Access Compliance Report

Public Rights-of-Way

Intersection ID: 25747	Main Street: HAMILTON_RD	Cross Street: SMITH_RD	Location: NE
ADA ID: 1DD405569C53	Ramp Type: Perp	Initial Pass/Fail: Fail	Overall Compliance: No
		Severity Score: 1.25

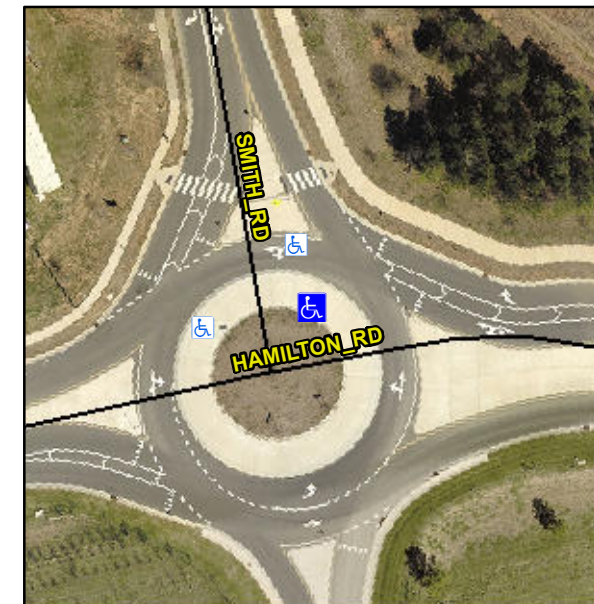
R304.5.3

Compliance	Description	Data	Compliance	Description	Data
N/A	Ramp Length (in)	96.0	Yes	Ramp Slope (%)	6.5
Yes	Ramp Width (in)	60.0	No	Ramp XSlope (%)	2.3
N/A	Flare Type LT	N/A	N/A	Flare Type RT	N/A
N/A	Flare Slope LT (%)	N/A	N/A	Flare Slope RT (%)	N/A
N/A	Flare Traversable LT?	N/A	N/A	Flare Traversable RT?	N/A
N/A	Landing Length (in)	N/A	N/A	DWS Provided?	N/A
N/A	Landing Width (in)	N/A	N/A	DWS Contrast?	N/A
N/A	Landing Slope (%)	N/A	N/A	DWS Length (in)	N/A
N/A	Landing X Slope (%)	N/A	N/A	DWS Full Width?	N/A
N/A	Landing Curb? (Y/N)	N/A	N/A	DWS Offset (in)	N/A
N/A	Shared Landing?	N/A			
N/A	Gutter Ponding?	N/A	N/A	Gutter Slope (%)	N/A
N/A	Gutter Lip Ht (in)	N/A	N/A	Gutter X Slope (%)	N/A
N/A	Painted X Walk1?	Yes	N/A	Painted X Walk2?	N/A
	X Walk 1 Direction	To W		X Walk 2 Direction	N/A
N/A	X Walk 1 Width (in)	120.0	N/A	X Walk 2 Width (in)	N/A
	X Walk 1 Slope (%)	2.2		X Walk 2 Slope (%)	N/A
	X Walk 1 X Slope (%)	2.0		X Walk 2 X Slope (%)	N/A

Remove & Replace Entire Ramp.
